Change Notification

Replacement of MH/MIS motors by Coveo® motors in After-Sales Service

History			
Index	Date	Description	Issuer
00	05/04/16	Creation	E. Miralles
01	12/04/16	Coveo® drilling template added	E. Miralles
02			
03			
04			
05			
06			
07			
08			
09			
10			
11

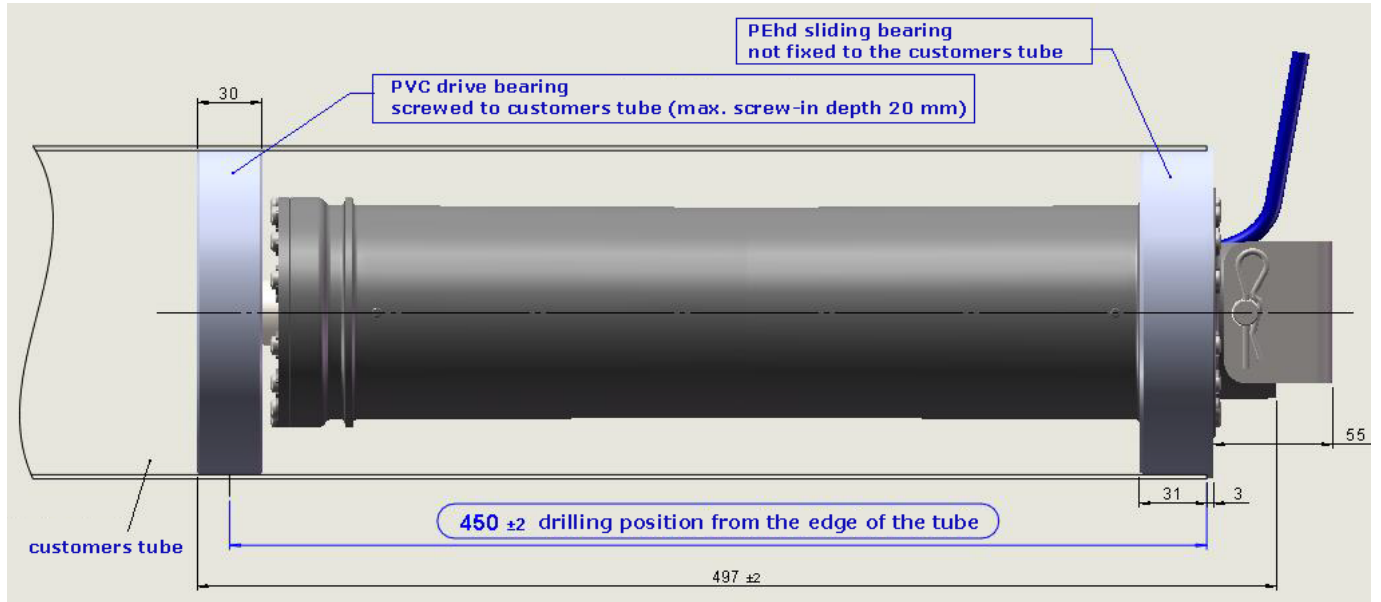
As a supporting rod for the motor's structure, the MH2 is equipped with a 16 mm square shaft. This is generally mounted in a rectangular tube on one of the sides, with a 16 mm square drilled through the tube wall.

The Coveo®'s attachment (bolt, flange or coupling) being free to pivot, the force exerted by the cover develops a bending force on the supporting tube (whereas in the case of an MH2, with the 16 mm square shaft connected to the motor, this force is top to bottom shear with no bending component).

The bending distorts the supporting tube's wall and the 16 mm square shaft is unsuitable: a firm connection to the supporting tube is required.

The above-ground Coveo® comes with a U-shaped flange (see diagram below) attached to the supporting tube via 4 holes (either smooth or threaded with a counter-plate to be added behind on the inside of the tube for tightening with nuts). Nylstop® nuts are recommended.

- ① **Drill new holes in the rectangular supporting post to adapt the new U-shaped flange to it,**
- ② **Drill new holes in the customer's tube because the distance between the motor's front bearing and rear bearing is not the same as on the MH2 (drilling pattern to be changed).**

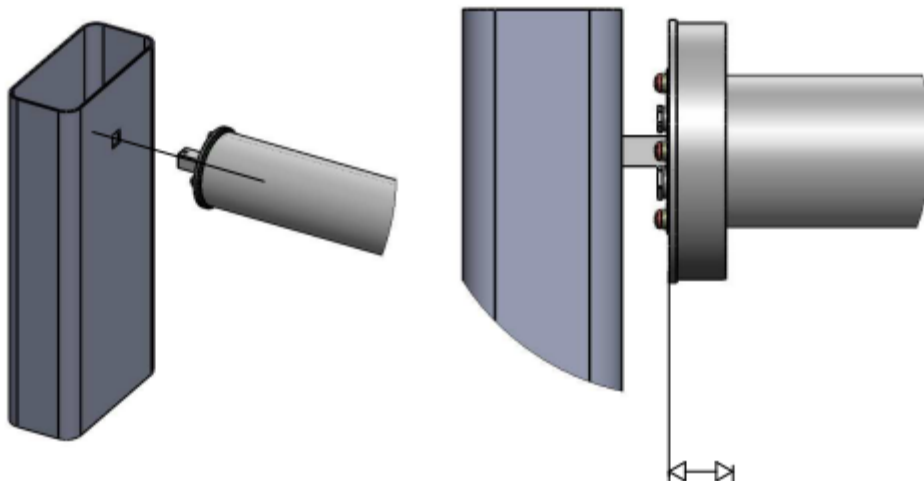
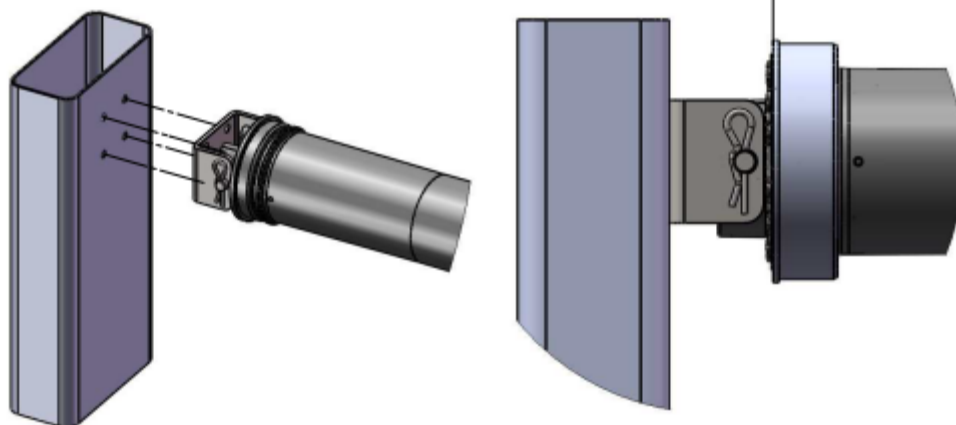
Adapting the U-shaped flange involves moving the cover's position (see the diagram below, on the right, to a varying degree, either more or less, depending on the customer's assembly) and requires:

- ③ **Checking if, on the other side of the pool, it is necessary to sink or remove the telescopic bearing shaft,**
- ④ **Checking if it is necessary to move the straps on the shaft (so that the apron is still centrally positioned in relation to the pool walls).**

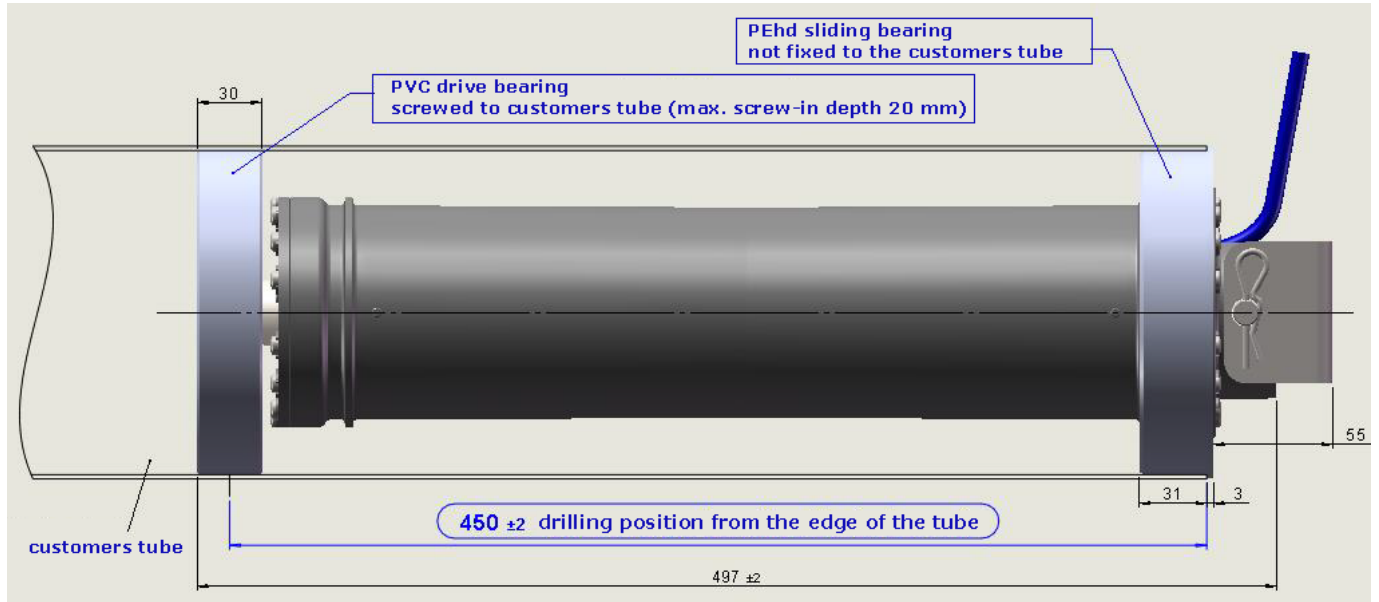
The Coveo®'s attachment (shaft) being free to pivot, the cover develops a bending force on the end-plate.

The bending can distort the end-plate depending on the latter's rigidity.

- Either the customer's validation of the end-plate's holding with an immersed Coveo® with shaft is sufficient, and in this case the shaft can have the same interfaces of attachment to the end-plate, which avoids any modification of the end-plate,
- Or, in the case of a too flexible end-plate, we can offer attachment using a coupling on the end-plate, which has the advantage of reducing the end-plate - force distance and therefore, the bending time.

- ① **Validate the choice of either a similar shaft or a coupling,**
- ② **Drill new holes in the customer's tube because the distance between the motor's front bearing and rear bearing is not the same as on the MIS (drilling pattern to be changed).**

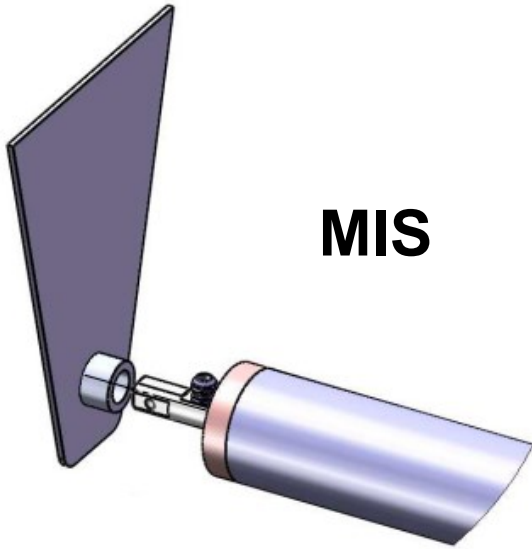
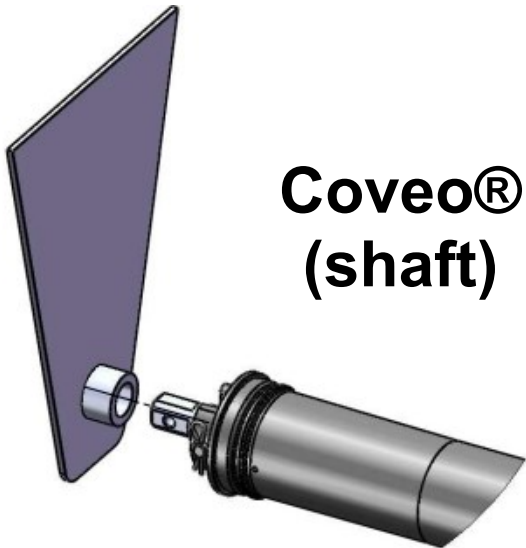
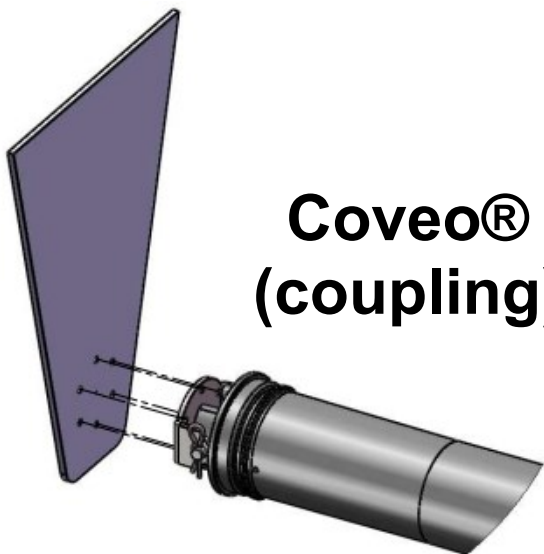
Adapting the Coveo®, whether with a similar shaft or a coupling, involves moving the cover's position (see the diagram below, on the right, with varying value, either more or less, depending on the customer's assembly) and requires:

- ③ **Checking if, on the other side of the pool, it is necessary to sink or remove the telescopic bearing shaft,**
- ④ **Checking if it is necessary to move the straps on the shaft (so that the apron is still centrally positioned in relation to the pool walls).**

3.3 Electrical wiring

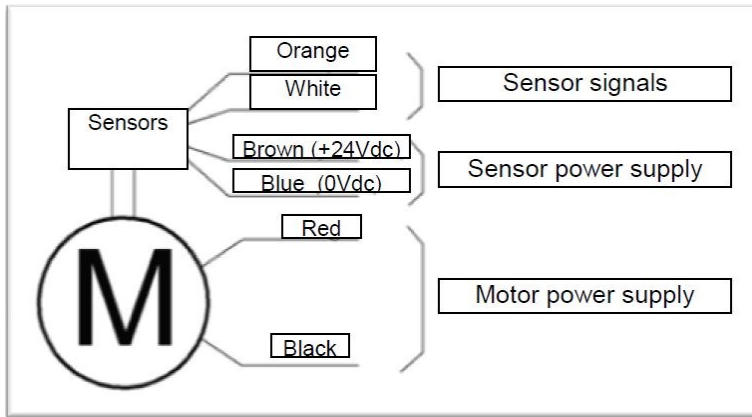
- Wiring the electrical motor to the control box remains the same except for the sensor wires in the case of a limit switched motor:
 - o Unlike the MIS, the Coveo® immersed motors have 2 sensors, therefore one extra wire,
 - o You only have to connect one of the 2 wires: either the orange one or the white one.
